**RE: Multi-Specialty Clinic
Grading and Drainage Plan
Engineer's Stamp Date 11-20-2015 (File: M15D026B)**

RE: Multi-Specialty Clinic Grading & Drainage (File M15-D026B)

Please find the following responses addressing staff comments from correspondence dated July 18, 2015 listed below:

ENGINEER'S SEAL	MULTI-SPECIALTY CLINIC 2901 TRANSPORT ST, S.E.	DRAWN BY DY
		DATE 11/06/15
		2015044-HORIZONTAL CONTROL
		SHEET # C1
JOEL D. HERNANDEZ P.E. #17893	 TIERRA WEST, LLC 5571 MIDWAY PARK PLACE NE ALBUQUERQUE, NM 87109 (505) 858-3100 www.tierrawestllc.com	JOB # 2015044

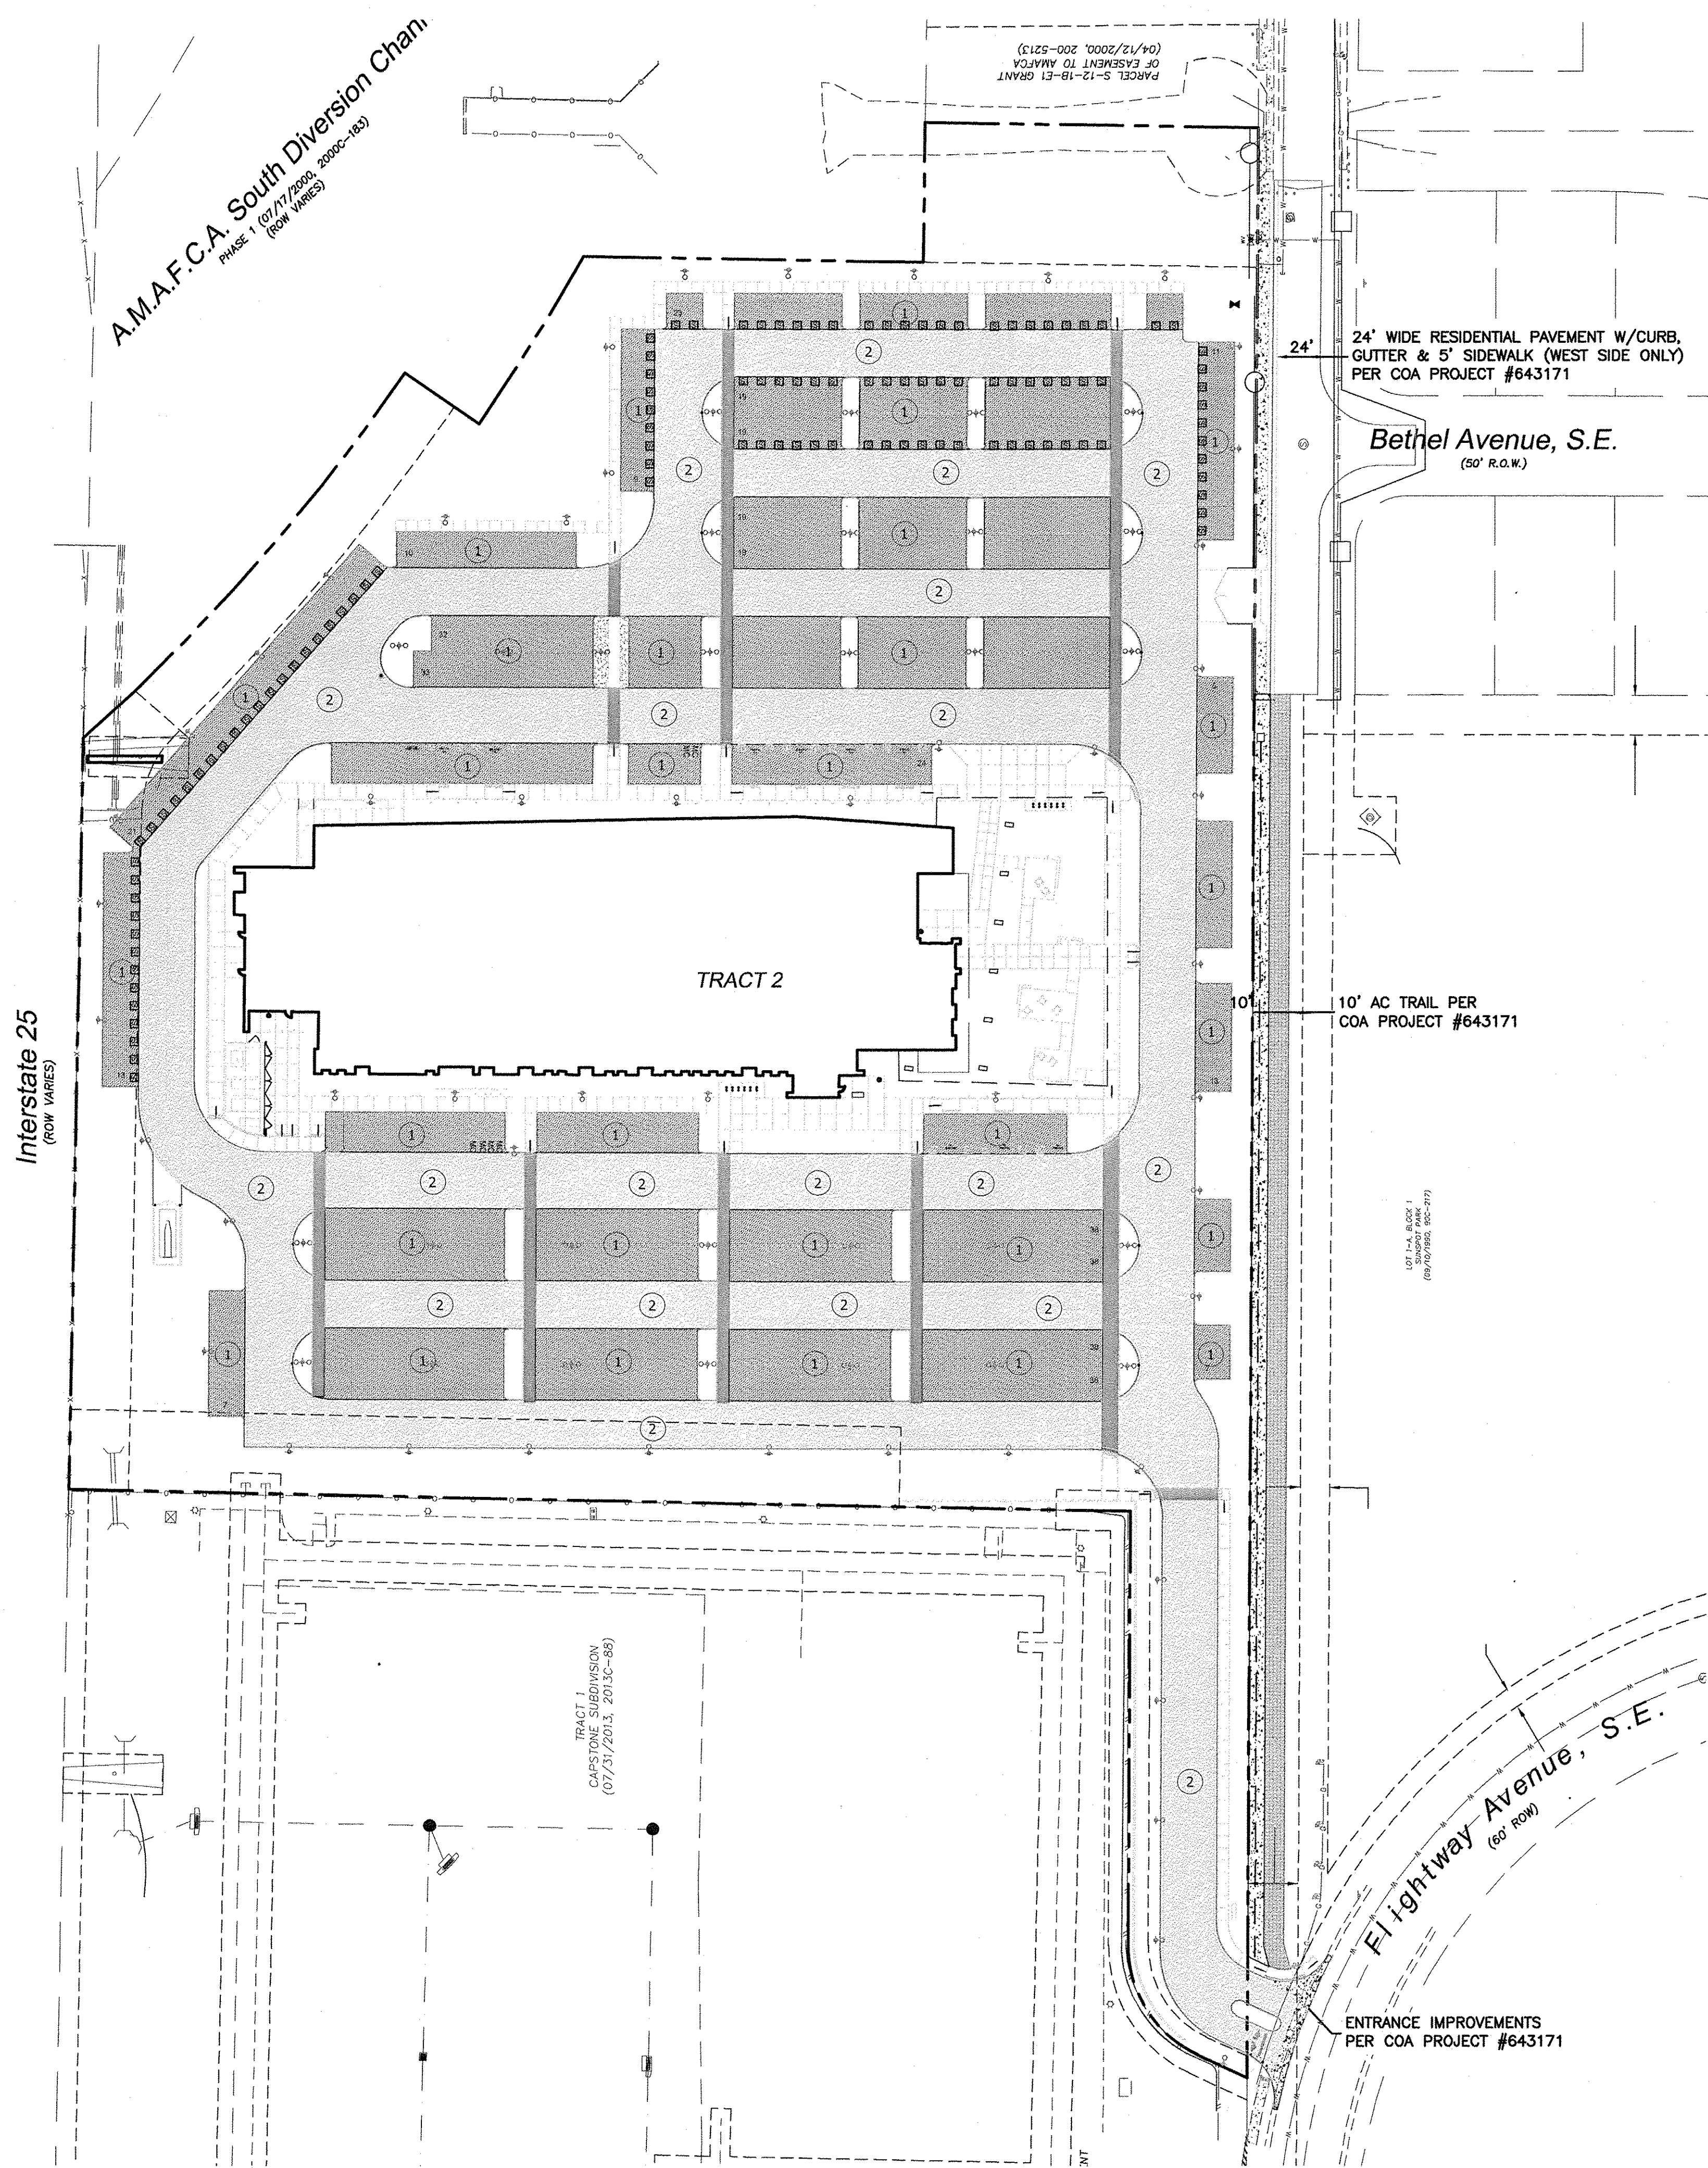
1. Provide show the retaining wall layout on the Site Plan.

4. Will "heavy duty" decorative concrete paving be defined within the plan set? (Thickness, reinforcement).

6. Ensure that all ADA ramps are shown on both the Site Plan and the Grading Plan Sheets.

Response: We are including the Horizontal Control Plan/Paving Plan (Sheet C1) which also depicts the retaining wall layout with this submittal.

Response: We are including the Horizontal Control Plan/Paving Plan (Sheet C1) which also depicts the various pavement sections.

Response: We are including the Horizontal Control Plan/Paving Plan (Sheet C1) which also depicts the ADA ramps, as well as plan sheet (Sheet GR-4) at 1"=20' to more clearly show the ADA access in the flatwork around the building.

JOEL D. HERNANDEZ P.E. #17893	ENGINEER'S SEAL	MULTI-SPECIALTY CLINIC 2901 TRANSPORT ST. S.E.	DRAWN BY DY
		GRADING AND DRAINAGE PLAN	DATE 11/06/15
		TIERRA WEST, LLC 5571 MIDWAY PARK PLACE NE ALBUQUERQUE, NM 87109 (505) 858-3100 www.tierrawestllc.com	2015044-GRB
			SHEET # GR-3
			JOB # 2015044

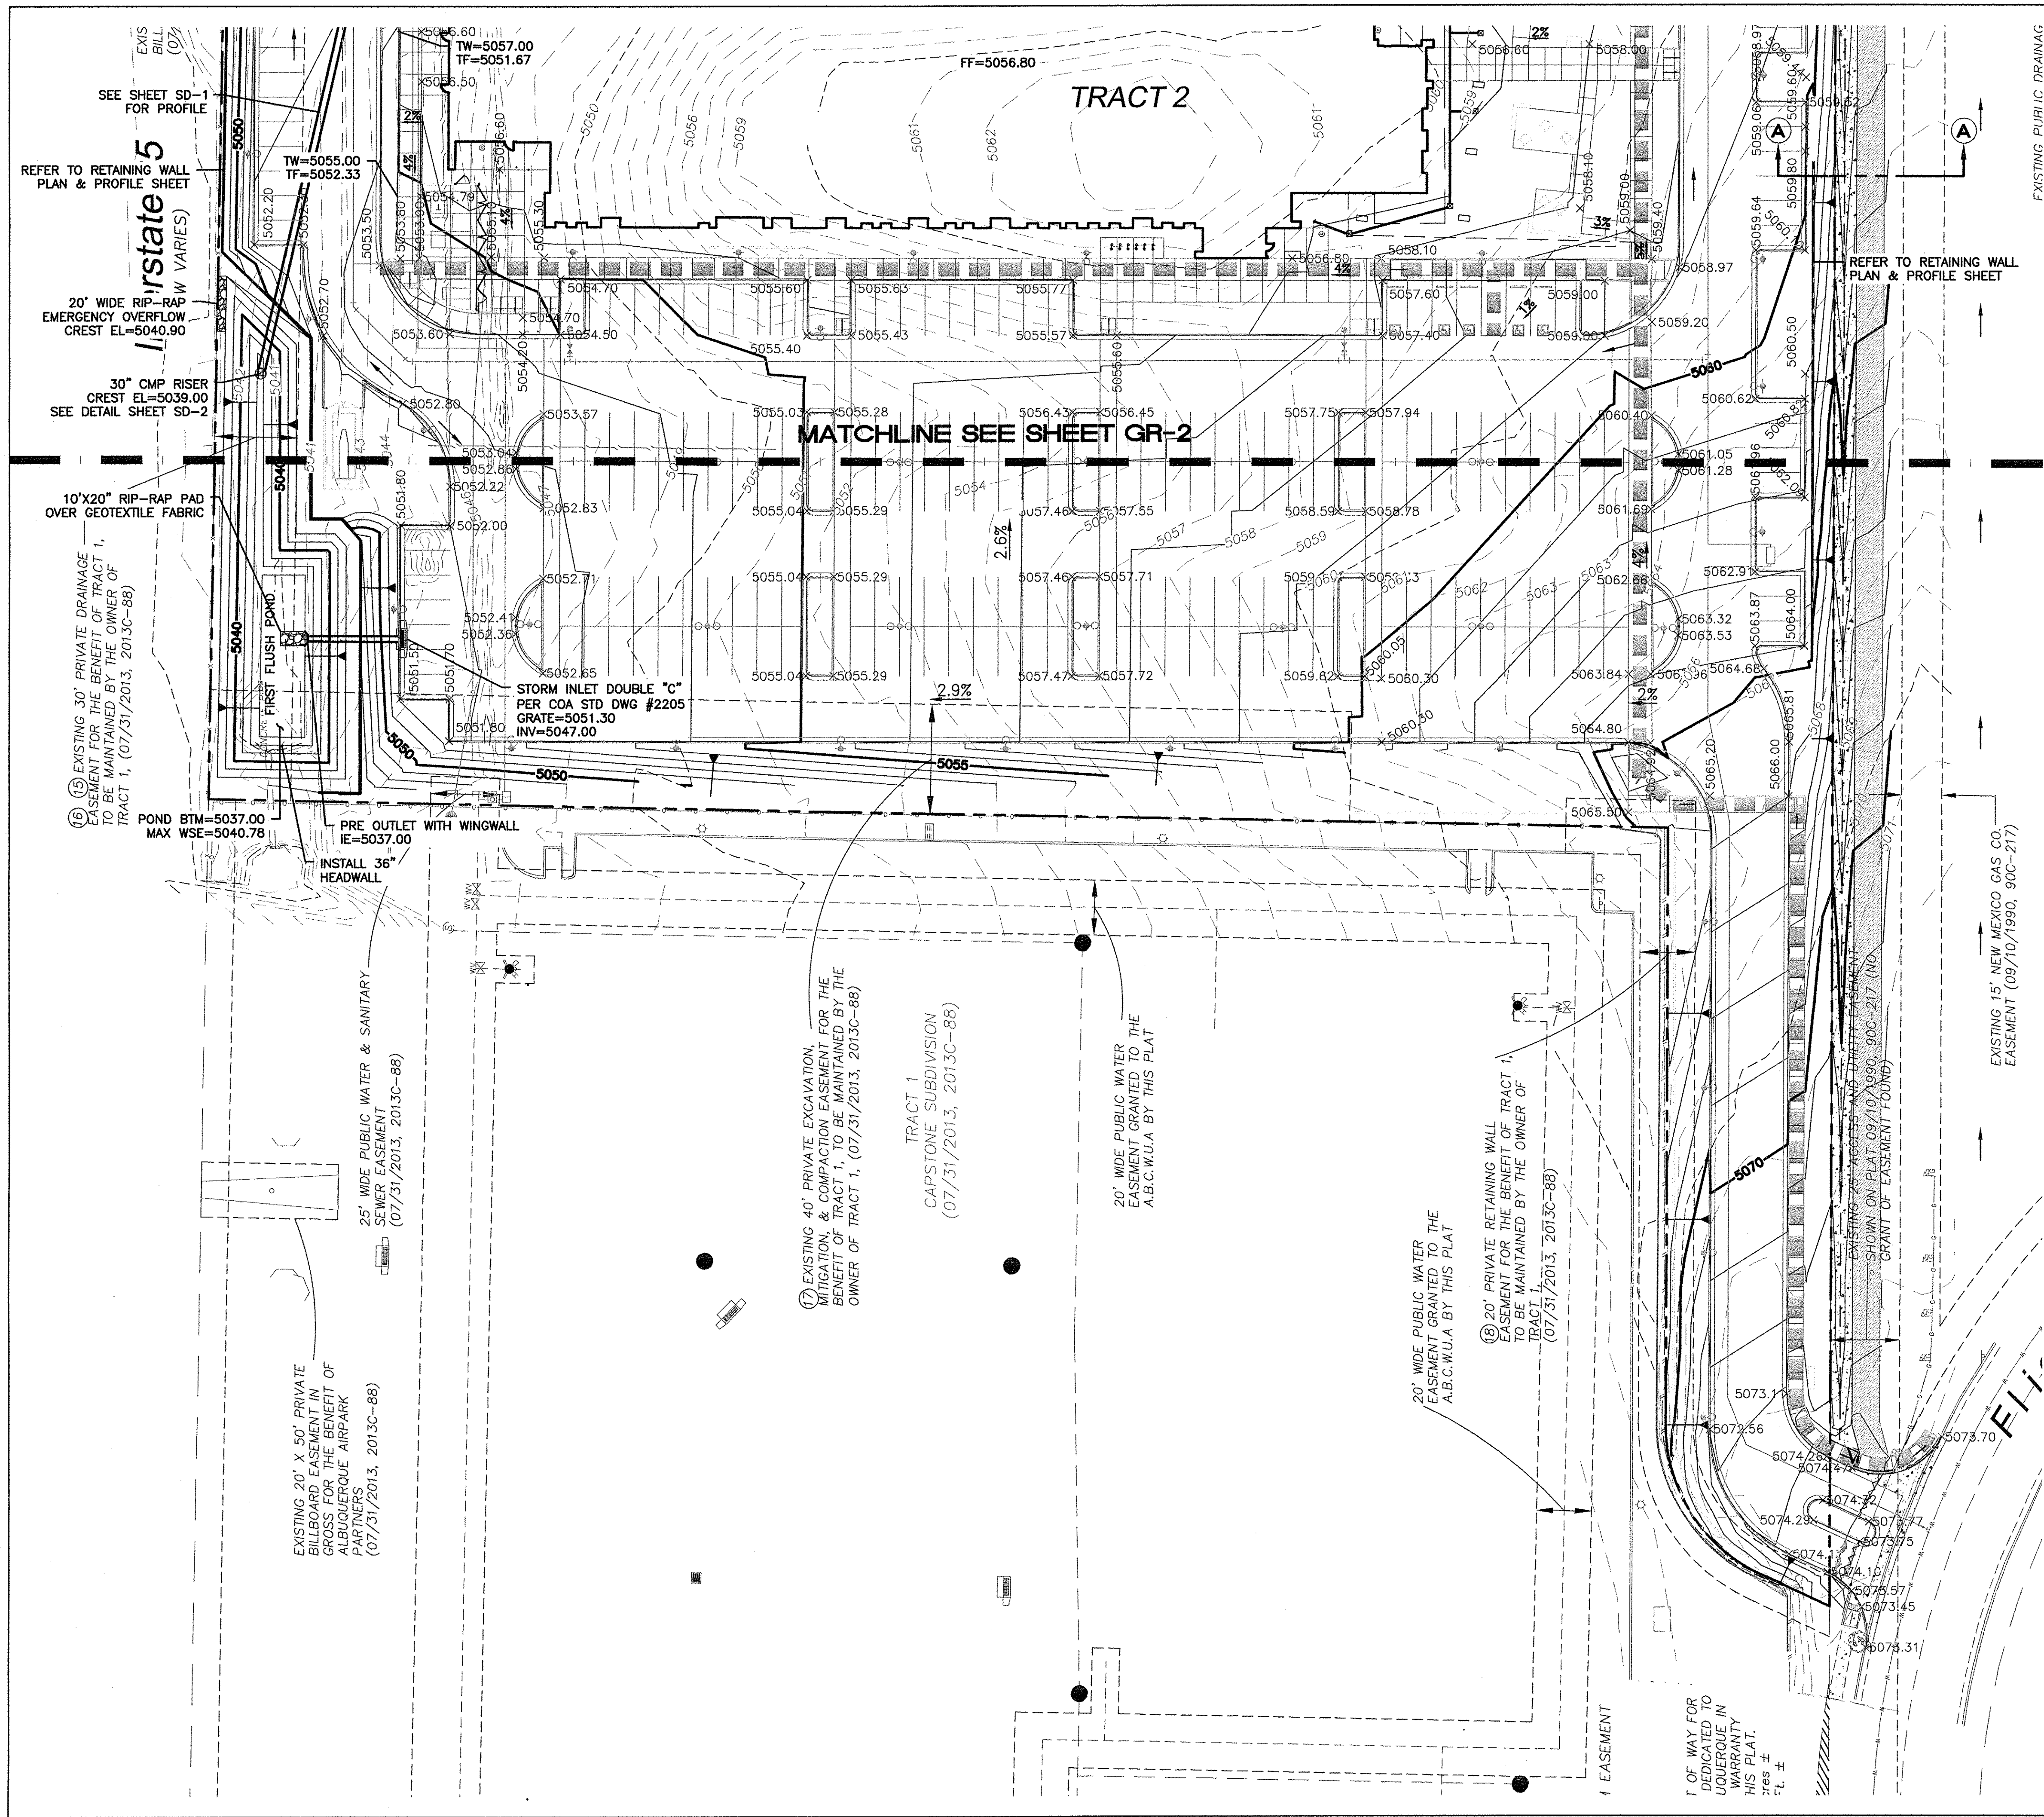
5. The grading plan does not appear to account for the construction of some of the ADA ramps, for example, Sheet GR-3, shows untied/conflicting contour line work and does not appear to give the contractor enough information to build the ramps correctly in the vicinity of

the retaining wall. Elevations shown for the ramp will likely not work with the header curb dimensions suggested on the Site Plan.

8. Show the pipe connection from Phase I as an existing structure to be preserved (or show new outlet structure improvements if that is the intent).

Response: We have updated the grading plan sheets to reflect the revision to the trail and more clearly show the proposed contours in ramp areas. Also included in this submittal is an additional plan sheet (Sheet GR-4) at 1"=20' to more clearly show the ADA access in the flatwork around the building.

Response: We have added a note to the grading plan (Sheet GR-3) to install an end section to the storm drain pipe.
